Re: **Rosemont Subdivision**
Response Letter
Project Number 2130073.00

In response to your plan review checklist dated July 30, 2013, we have addressed the items below, with our responses following your comments.

SUBDIVISION RESUBMITTAL - AUGUST 28, 2013

1 EXISTING CONDITIONS PLAN
C2.0 1"=30'

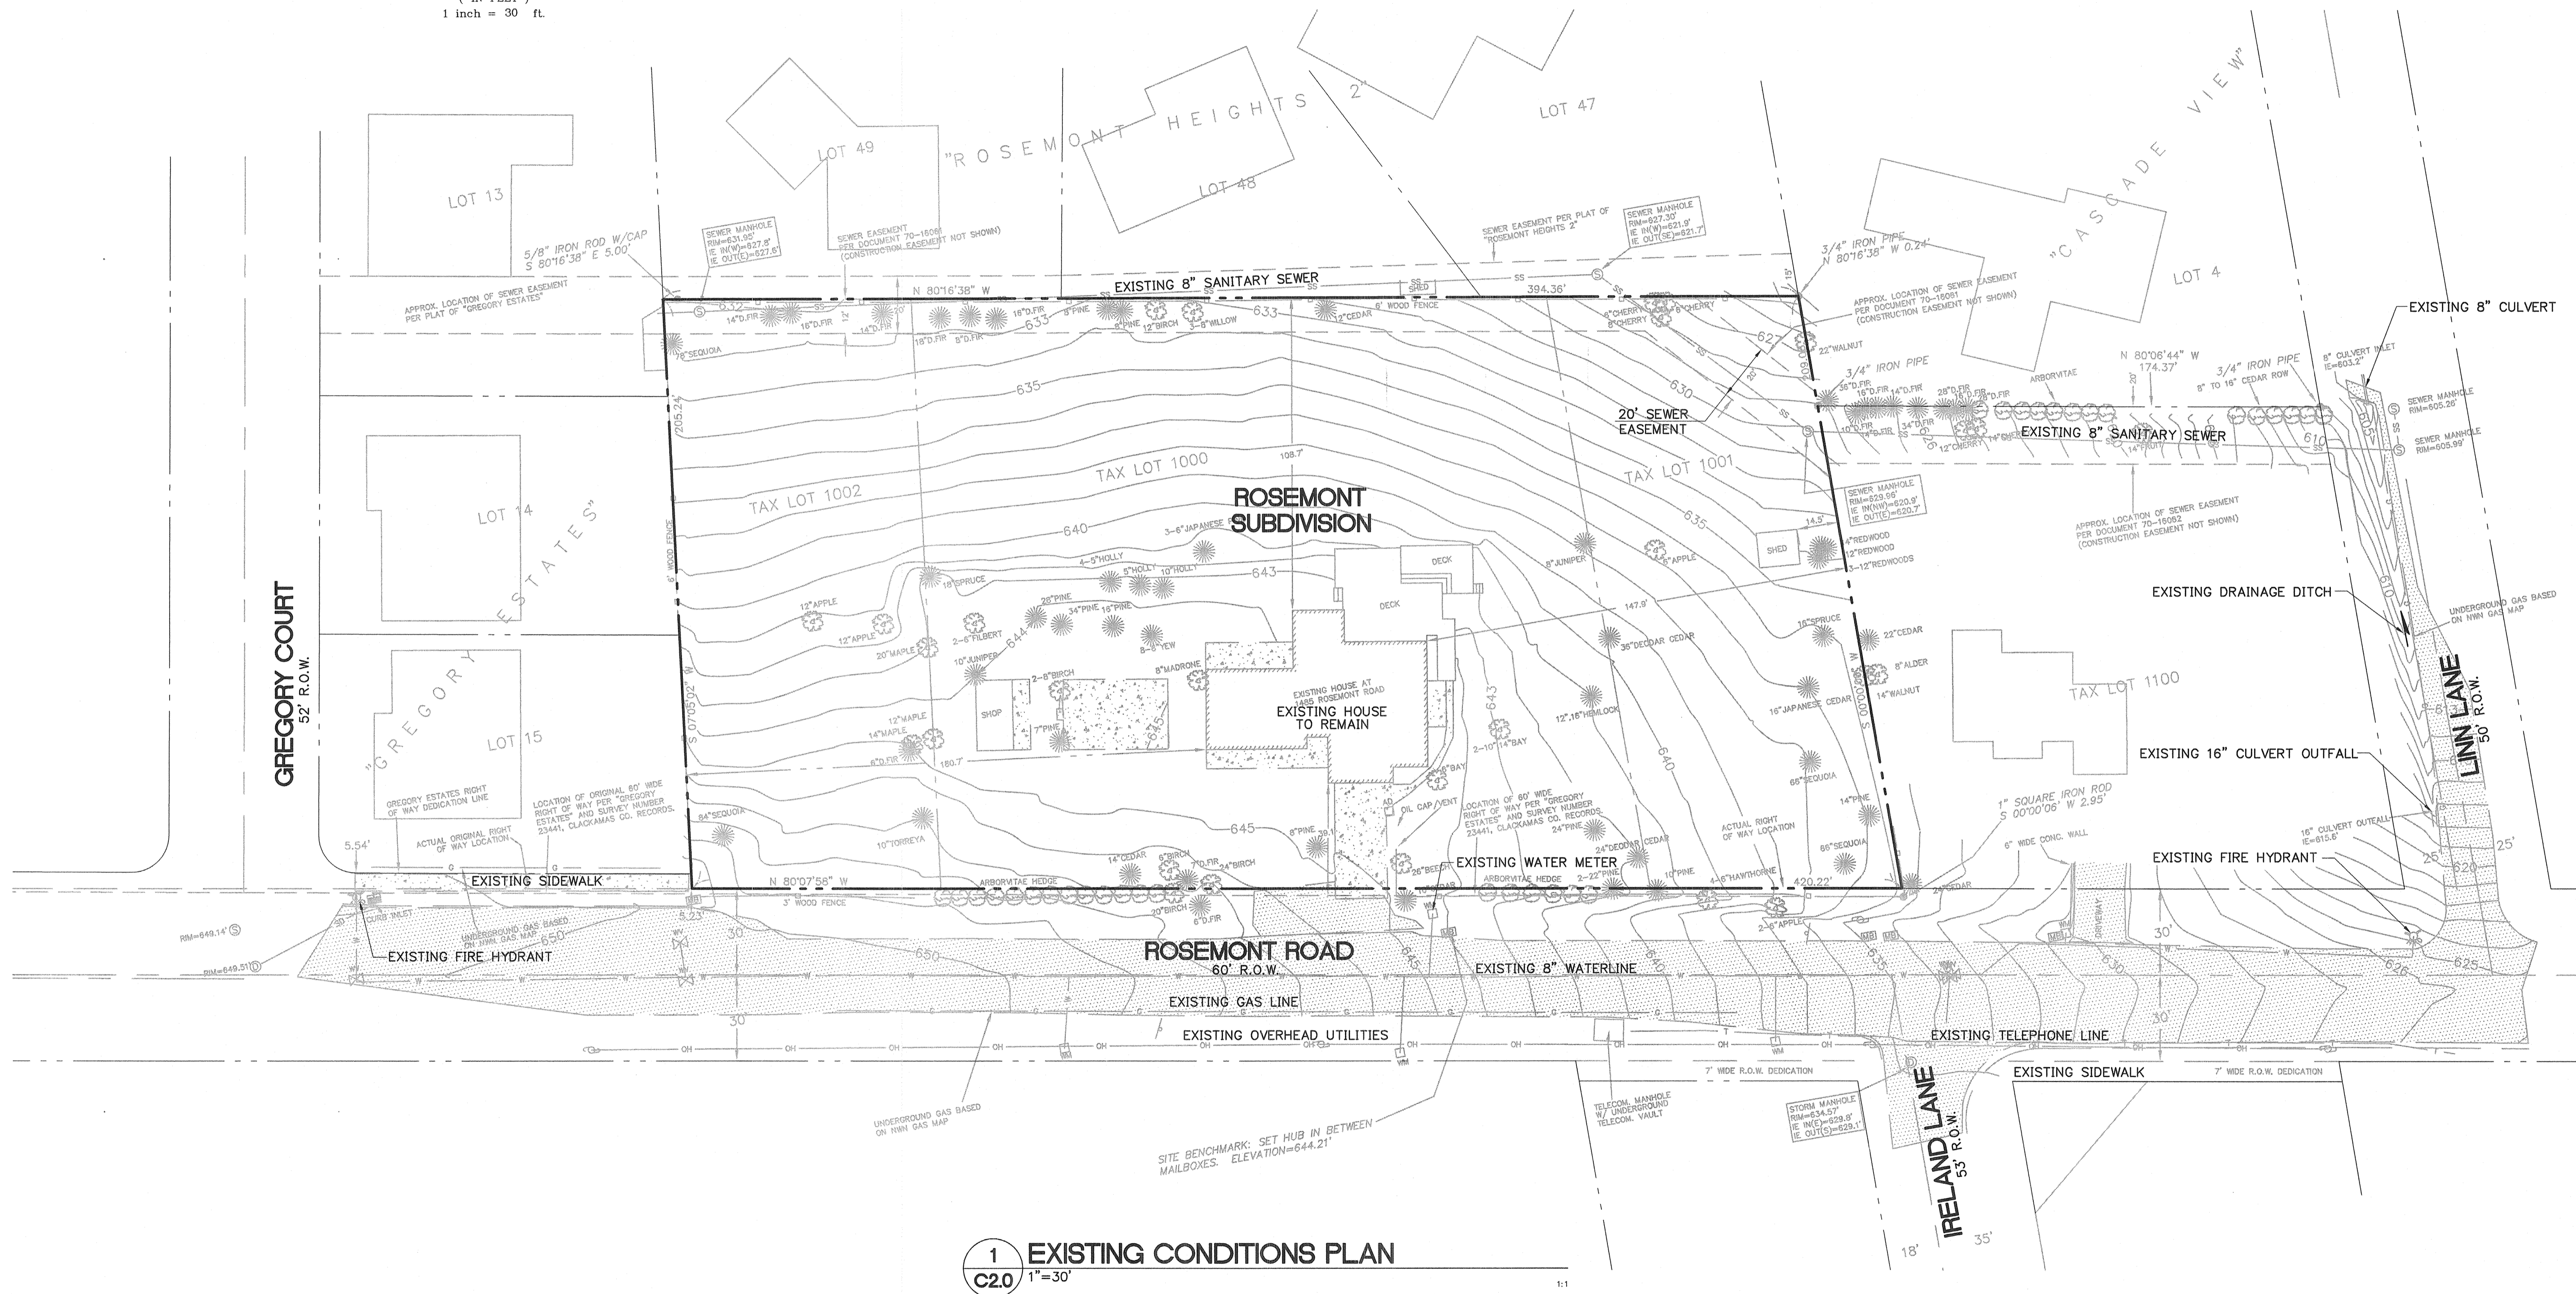
1. *Submit 11 x 17 size of the "Topographic Survey..." that you submitted in 24 x 36 size, and provide electronic copy. Submit electronic copy of paper neighborhood meeting materials.*

Response: An 11x17 Topo Survey (C2.0 in plan set) has been provided. Kelly Pyrch has provided the electronic copy of the neighborhood meeting materials.

1 TENTATIVE SUBDIVISION PLAN
C3.0 1"=30'

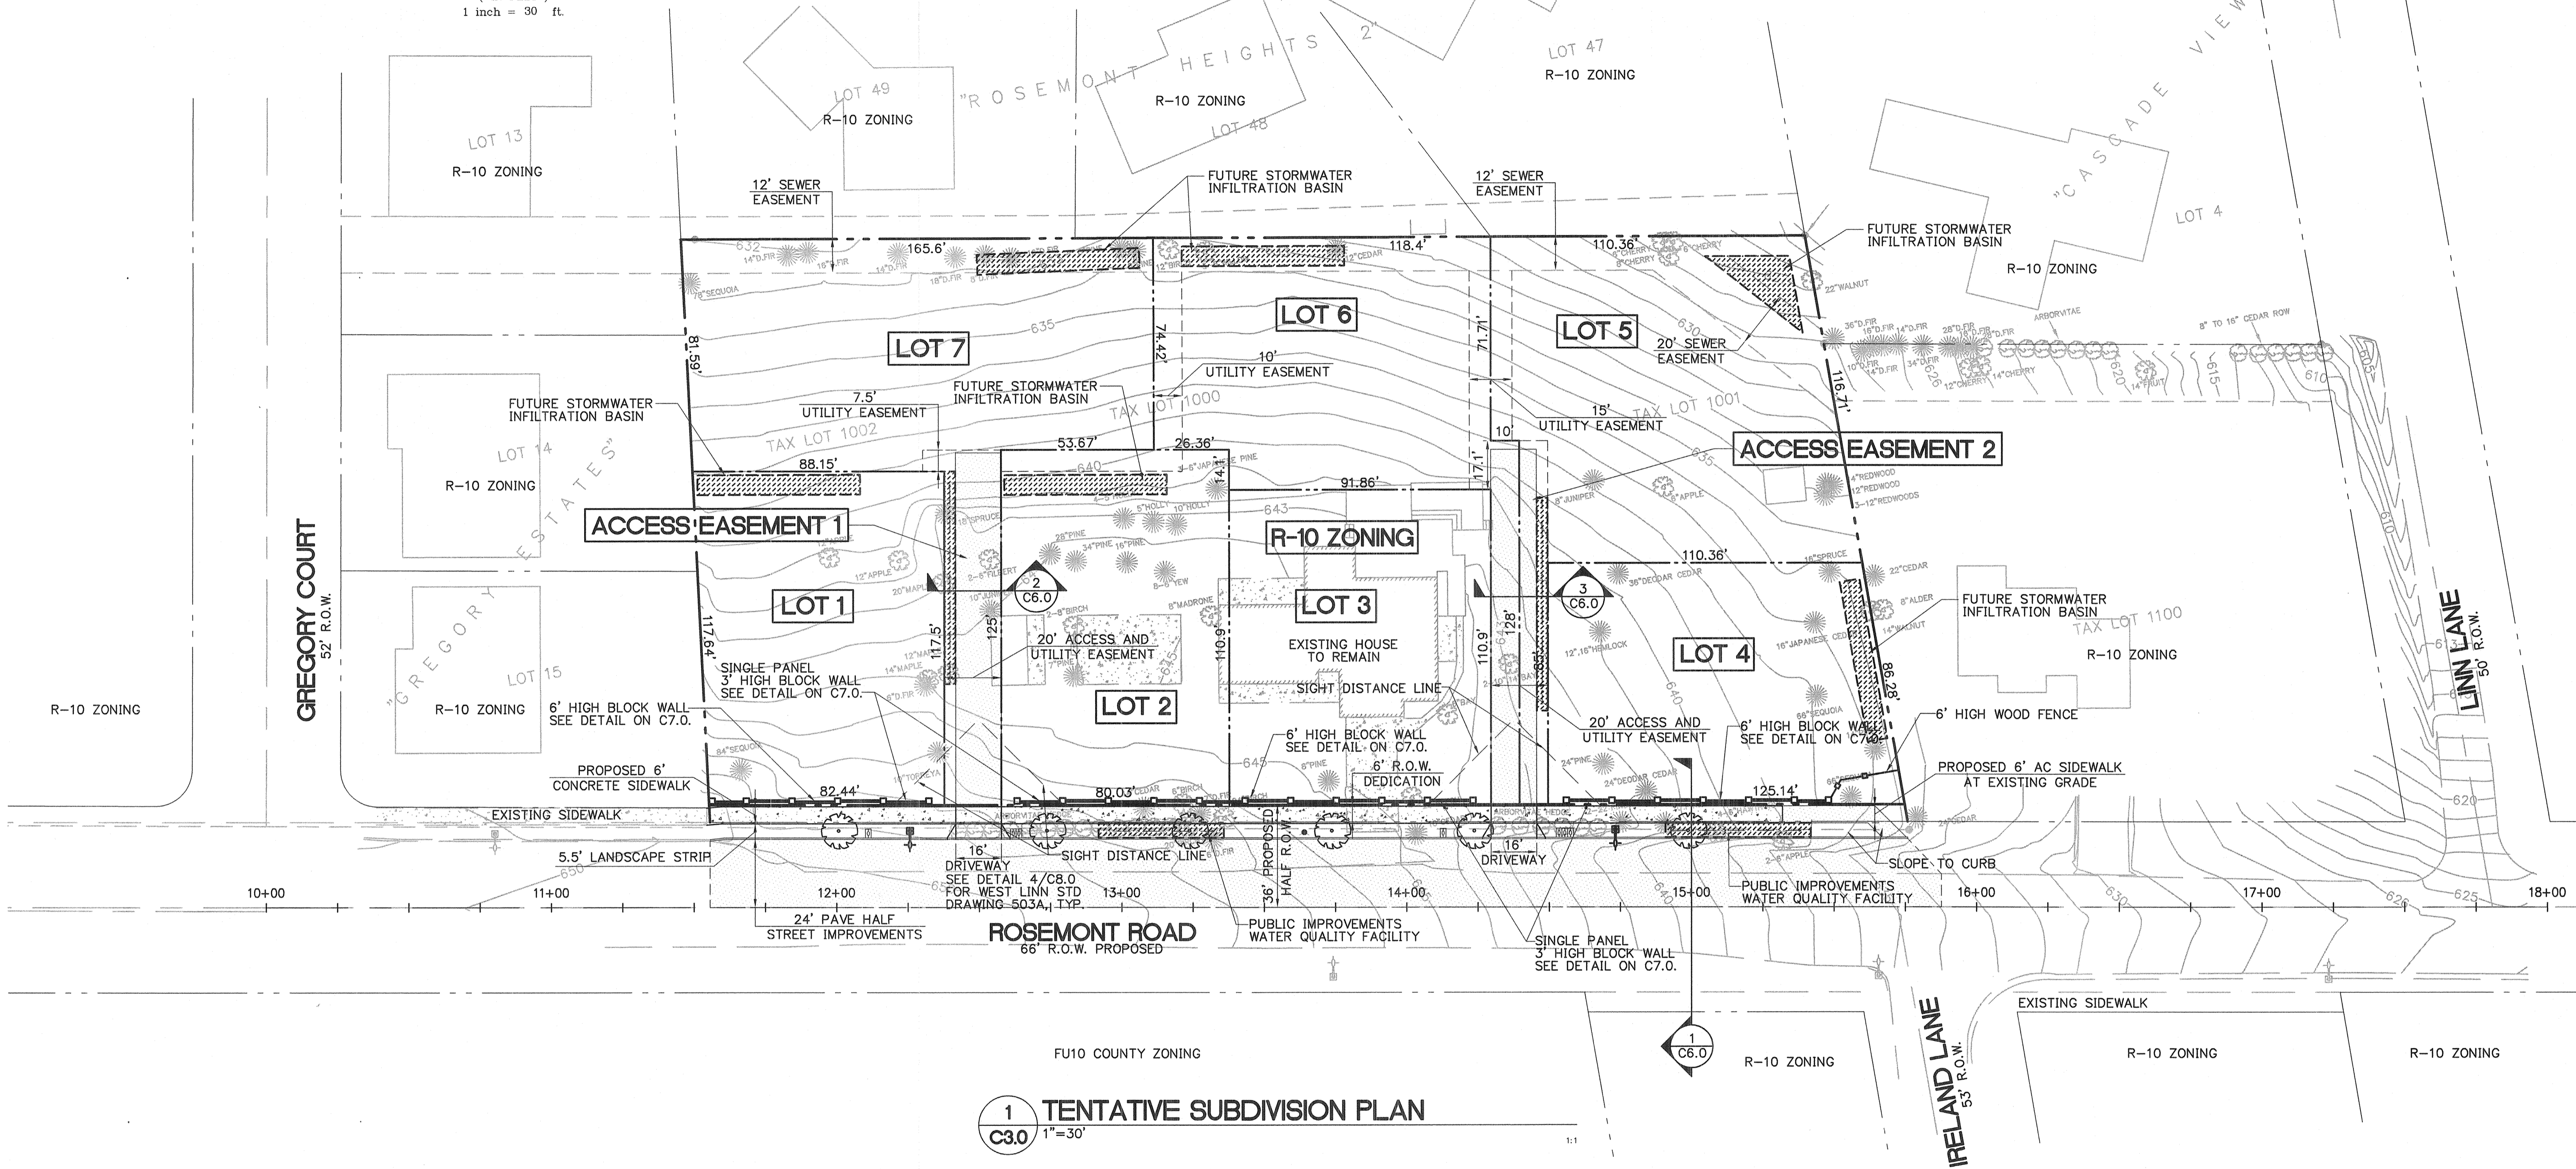
4. *Provide these contours on tentative subdivision plan.*

5. *Tell on tentative plan the percentage of land that is significant tree protection area and the percentage of Non-Type I and II lands that are significant tree protection areas.*

6. *Show on tentative plan the zoning of this and surrounding properties including county zoning across the street.*

7. *Show on tentative plan the buildings on adjoining property.*

Response: Contours are now shown on the tentative plan.

Response: Percentage of land in significant tree protection area have been added to the tentative plan. No Type-I or Type-II lands on the site.

Response: Zoning of subject property and surrounding properties are now shown on the tentative plan.

Response: Buildings on adjoining property are now shown on the tentative plan.

SHEET TITLE:
TREE PROTECTION PLAN

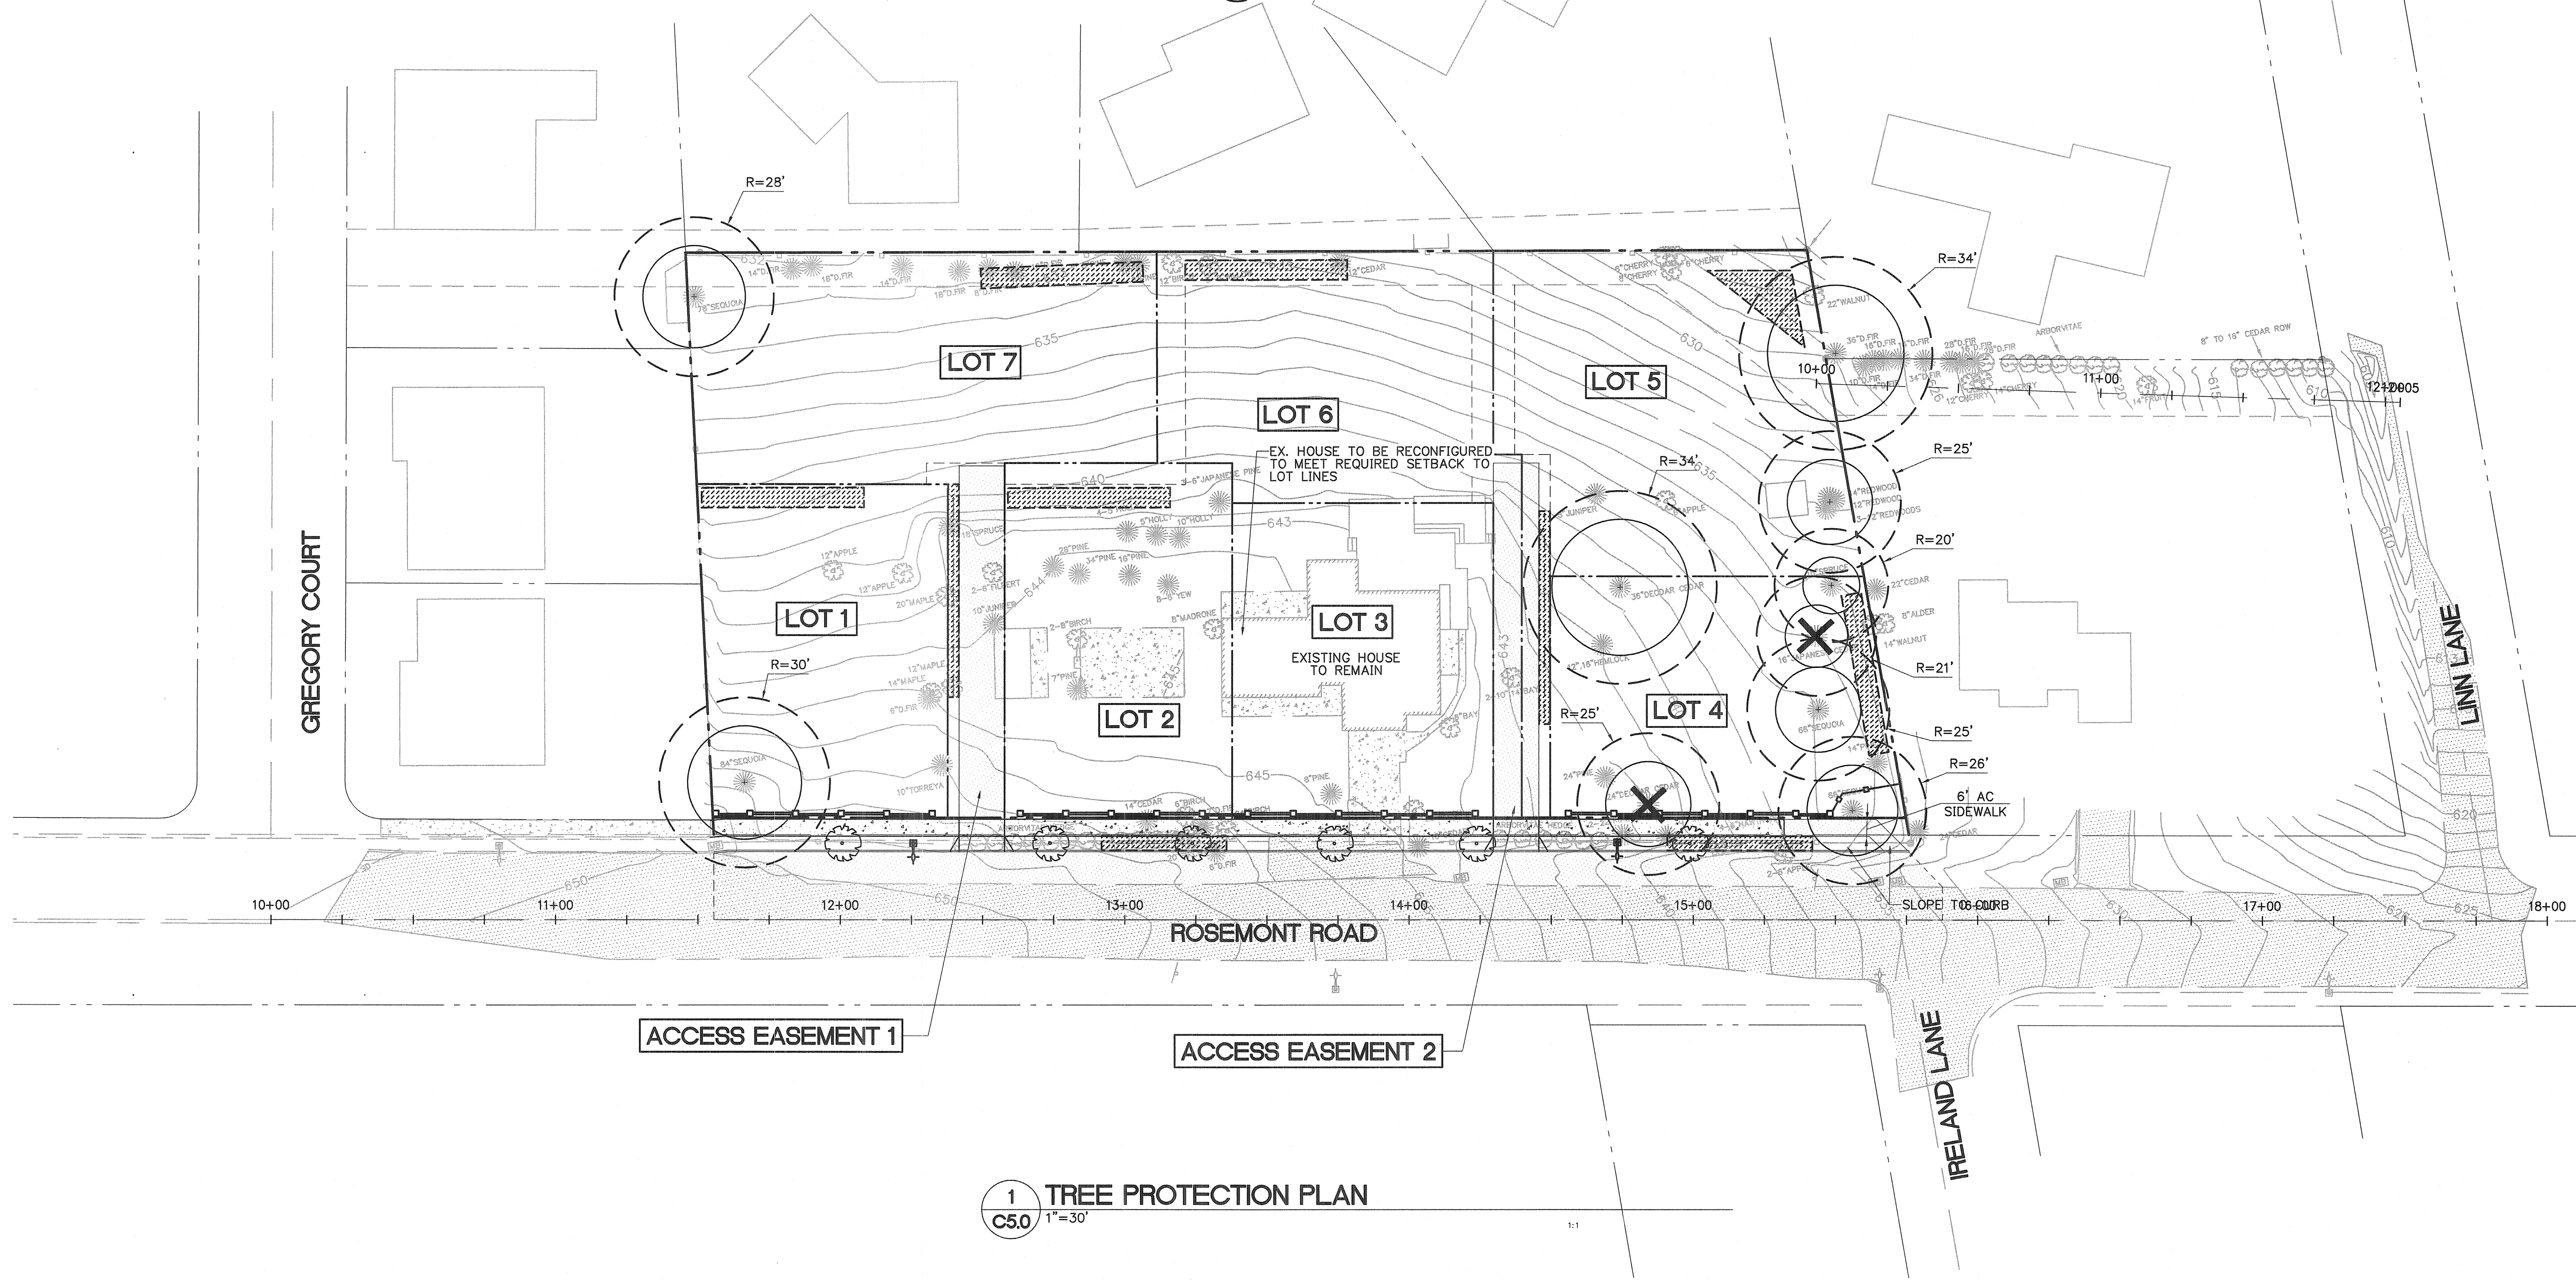
9. *This section addresses significant trees, not just heritage trees. Respond regarding significant trees.*

Response: Significant tree information is now shown on tree plan and tentative site plan. A variance regarding the site trees has been provided to the City, but is not expected to be needed.
